Access Compliance Report

Public Rights-of-Way

(Curb Ramps)

Intersection ID: 11799	Main Street: MECKLENBURG_AV	Cross Street: NORCROSS_PL	Location: NW
ADA ID: 06F1FF36B805	Ramp Type: Perp	Initial Pass/Fail: Pass	Overall Compliance: No
		Severity Score: 0

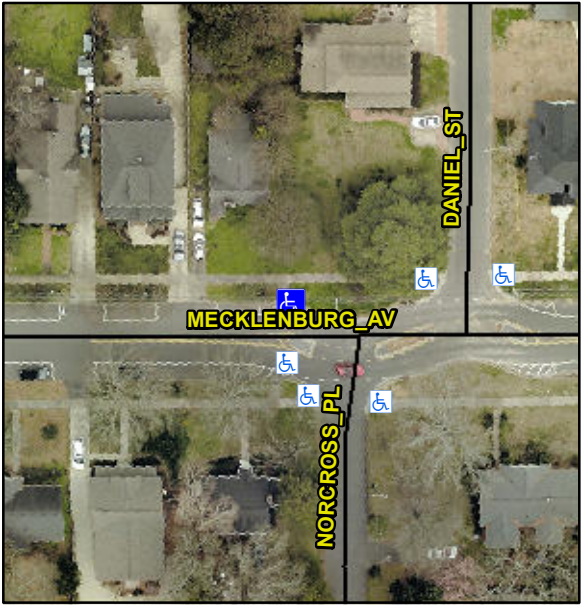
Codes/Mitigation Info/Possible Solution			Field Measurements/Component Compliance		
	Possible Solutions:		Compliance	Description	Data
	Remove & Replace Landing. Remove & Replace Gutter.		Compliance	Description	Data
	Surveyor Notes:		Yes	Ramp Length (in)	114.0
	N/A		Yes	Ramp Width (in)	58.5
	PROW/ADA:		Yes	Flare Type LT	Curbed_NoWalkSurface
	R304.2.2-Perp, R304.3.2-Para, R304.5.3		Yes	Flare Slope LT (%)	N/A
			N/A	Flare Traversable LT?	No
			Yes	Flare Slope RT (%)	N/A
			N/A	Flare Traversable RT?	No
			Yes	Landing Length (in)	61.0
			Yes	Landing Width (in)	61.0
			Yes	DWS Provided?	Yes
			No	DWS Contrast?	Yes
			Yes	Landing Slope (%)	2.7
			Yes	DWS Length (in)	24.0
			No	DWS Full Width?	Yes
			Yes	DWS Offset (in)	0.0
			No	Landing X Slope (%)	3.0
			N/A	Landing Curb? (Y/N)	No
			Yes	Shared Landing?	No
			Yes	Gutter Ponding?	No
			Yes	Gutter Slope (%)	1.2
			No	Gutter Lip Ht (in)	0.0
			No	Gutter X Slope (%)	3.3
			N/A	Painted X Walk1?	N/A

N/A	Painted X Walk2?	N/A
			N/A	X Walk 1 Direction	To S
			N/A	X Walk 2 Direction	N/A
			N/A	X Walk 1 Width (in)	N/A
			N/A	X Walk 2 Width (in)	N/A
			N/A	X Walk 1 Slope (%)	3.4
			N/A	X Walk 2 Slope (%)	N/A
			N/A	X Walk 1 X Slope (%)	1.5
			N/A	X Walk 2 X Slope (%)	N/A
			N/A	Ramp inside XWalk1?	N/A
			N/A	Ramp inside XWalk2?	N/A
			N/A	Road Slope (%)	N/A
			N/A	Clear Space?	Yes
			N/A	Clear Space to XWalk (in)	N/A
			N/A	Storm Grate/Utility Hazard?	No
			Yes	Storm Grate/Utility Type	
			No	Obstruction Type	
			N/A		N/A
			Yes	Surface Condition? (G/P)	Good
